Beckfoot & Hazelbeck School - Accessibility Action Plan.

Updated: 10/01/2025

13.11

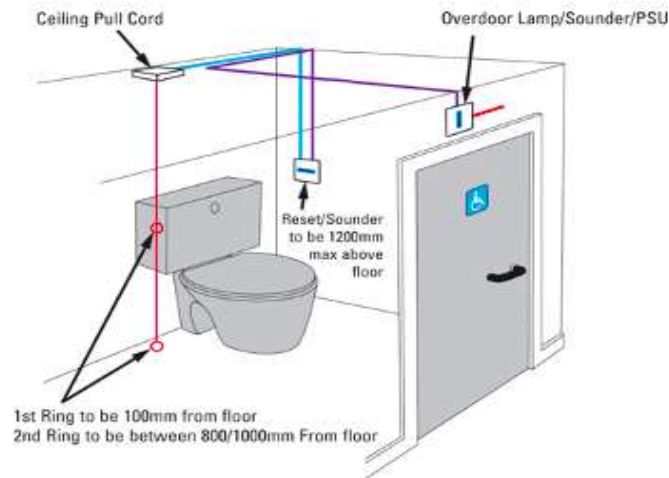
Cord alarms across the facilities were unsuitably positioned.

The cord alarms in HK 55C, HK57C, HK60.3, and HK60.2 were tied and not hanging within a suitable distance to the floor.

A broken cord alarm was identified in HK57B.

No cord alarm systems were identified in HK58B or HK58E.

Cord alarms in HK60.4 and HK57E were positioned behind items and could be difficult to access.

Should someone using these facilities required the cord alarms, but cannot reach them, their distress calls may go unnoticed.

Implement a management procedure to ensure that cord alarms are always kept loose and not tied up.

According to BS8300 - An emergency assistance pull cord should be sited so that it can be operated from the WC and from an adjacent floor area. The emergency assistance pull cord, coloured red, should be provided with two red bangles of 50 mm diameter, one set at a height between 800 mm and 1000 mm and the other set at 100 mm above floor level.

Utied - Amey to monitor on routine check
MJA to check
Hygeine rooms not requiring alarm
Students generally have supervision and no incidents in the last 12 years regarding these toilets. Teaching staff and support have access to all the student EHCP and would put in appropriate support

13.5

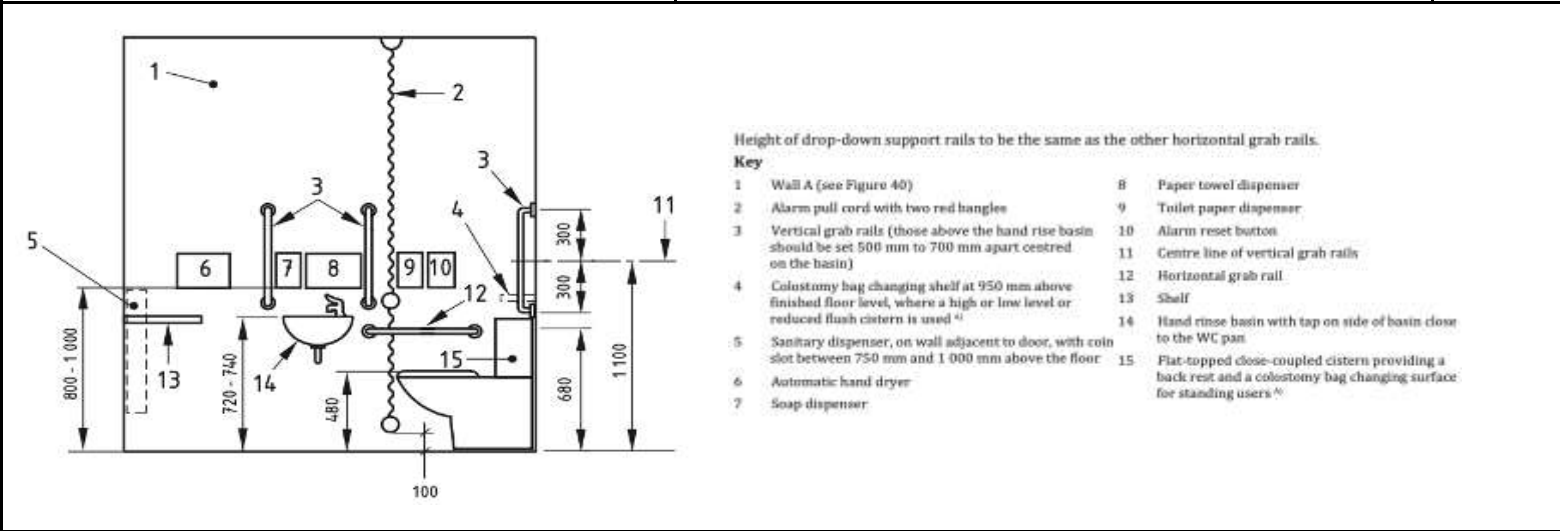
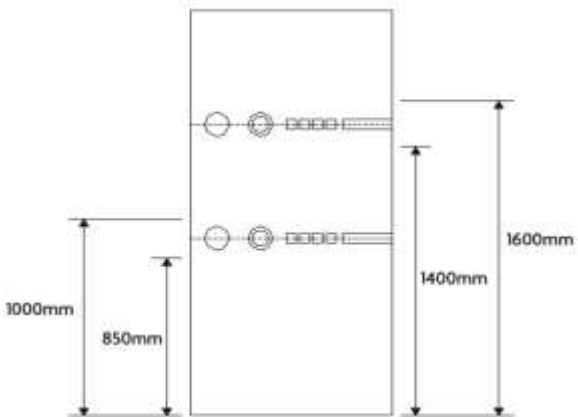
The soap dispenser was not provided at a height of approximately 1050mm in HK60.1.

The hand towel dispenser was high in HK57B, at approximately 1215mm.

There are fittings across the WC facilities that do not provide contrast against their surroundings as they are white against a light background.

The dispensers should be relocated at a height of between 800mm and 1000mm above finished floor level., as indicated by BS8300 Figure 42.

Greater contrast should be considered for the fixtures and fittings within the WCs. This can be achieved by having light sanitary ware seen against a dark background or vice versa.

According to BS8300 - to help blind and partially sighted people identify key objects within sanitary accommodation, support rails and grab rails should contrast visually with the wall, the WC seat and cover should contrast visually with the WC pan and cistern, and sanitary fittings and accessories should contrast visually with the background against which they are seen.

These are in the correct location. Students generally have supervision and no incidents in the last 12 years regarding these toilets. Teaching staff and support have access to all the student EHCP and would put in appropriate support.
